STATE OF WASHINGTON  
DEPARTMENT OF ECOLOGY

November 20, 2012

**Re: Further Action at the following Site:**

- **Site Name:** Chehalis Power LP Generation Facility
- **Site Address:** 1813 Bishop Road
- **Facility/Site No.:** 3336951
- **Cleanup Site ID No.:** 11776
- **VCP Project No.:** SW1246

Fig.3 Soil Confirmation sample locations and groundwater Site Investigation Surrounding GSU#1

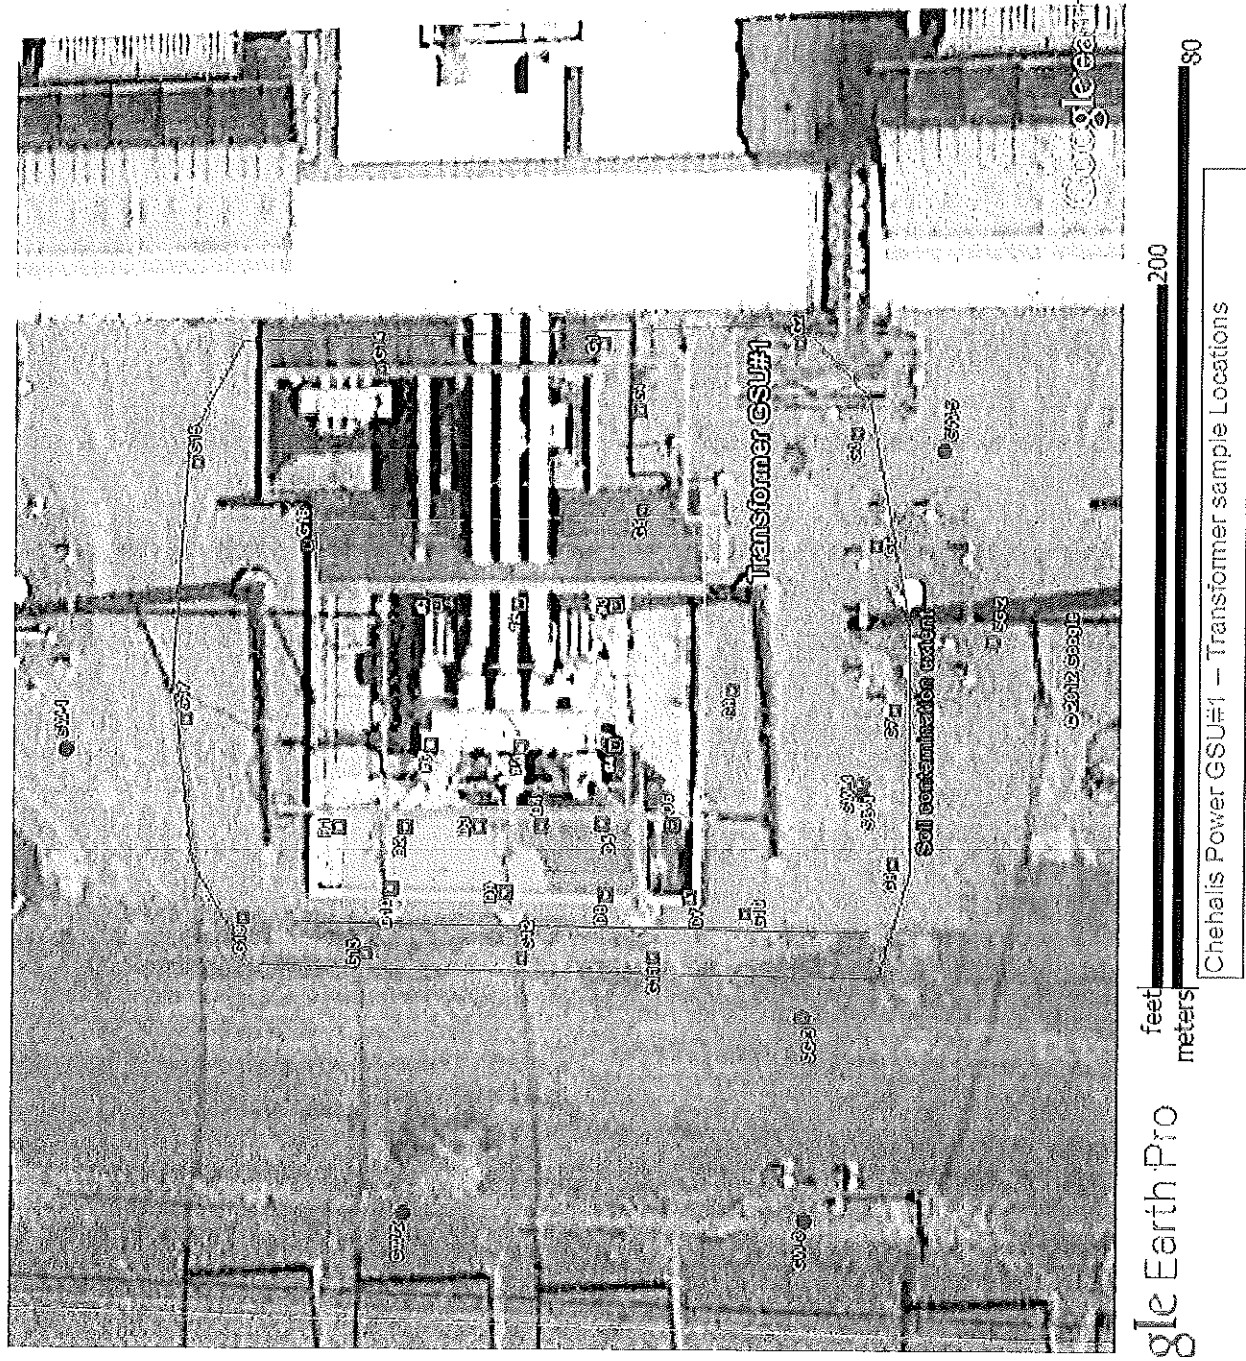
2. **Soil Around GSU #1:** Three separate confirmation soil sampling efforts were conducted to evaluate the cleanup of soil contamination surrounding the GSU#1 (see Fig. 3 of **Enclosure A**), and the results demonstrated that soil contamination still exists in a limited area under the extension portion of the newly enlarged GSU#1 containment structure.

1. Soil contamination was found in a limited pocket in the area under the newly extended portion of the GSU#1 containment. The concentration of mineral oil at 20 inches depth was 28,100 mg/kg, exceeding the MTCA cleanup level. The contaminated soil is now covered under the enlarged concrete containment structure. Additional remediation is needed. Alternatively, an environmental covenant may be put on the Site if additional remediation is deemed infeasible, in which case, please provide a brief feasibility study and disproportionate cost analysis that evaluates alternatives for cleanup in this area.
